SUPPLEMENTARY MEMORANDUM

HUNTER AND CENTRAL COAST REGIONAL PLANNING PANEL

PANEL REFERENCE & DA NUMBER	PPSHCC-147- MA2022/00286 (DA2019/00711) File Number 2019/39309 EXP No 1 National Park Street Pty Ltd v Newcastle City Council
LGA	City of Newcastle (CN)
PROPOSED DEVELOPMENT	Section 4.56 Modification to a Development Application for a mixed used development comprising demolition, retail, commercial, public spaces, residential apartments, associated parking, staging, and stratum subdivision.
STREET ADDRESS AND OWNER DETAILS	Lot 1171 in DP 858465; Lot 1181 in DP 596950; Lot 99 DP 1134475; Lot 1 in DP 741514; and Lot 100 in DP 612505. 1, 17, 19 National Park Street and 434 King Street Newcastle West
APPLICANT	GWH BUILD DEVELOPMENTS PTY LTD
OWNER	EXP NO 1 National Park Street Pty Ltd
DATE OF DA LODGEMENT	26 August 2022
ORIGINAL DA DETERMINATION DATE	21 September 2020 Jurisdiction: Class 1 File Number 2019/393097
APPLICATION TYPE	Modification Application under 4.56
REGIONALLY SIGNIFICANT CRITERIA	Clause 2, Schedule 6 of <i>State Environmental Planning Policy (Planning Systems) 2021</i> : General development with a CIV greater than \$30 million. Section 275 of the <i>Environmental Plan

Mark-up of Ground Floor Commercial Parking to accommodate End User facility and bicycle parking.

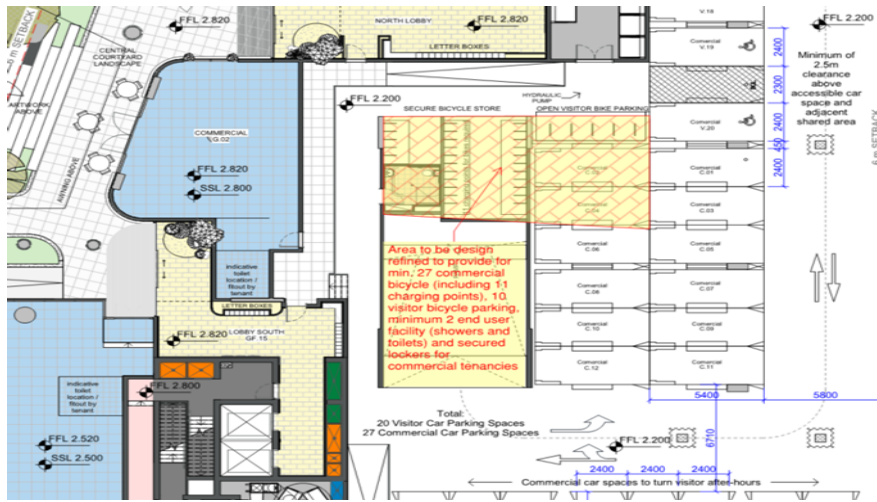
The revised plans propose approx. 27 bicycle parking spaces for commercial use and 10 visitor bicycle spaces on the ground floor car parking level. One end user shower and toilet facility are provided. CN DCP requires provision of at least two end user facility with the provision of secured lockers.

The removal of two (2) commercial parking spaces and redesign of the proposed area to allow for additional showers, toilets, change rooms, lockers alongside bicycle parking will allow for cyclists to use the area at one central location.

The current proposal is for use of the commercial unit toilet facilities as change and shower rooms, it is hard to comment on how this can practically be managed in an office environment.
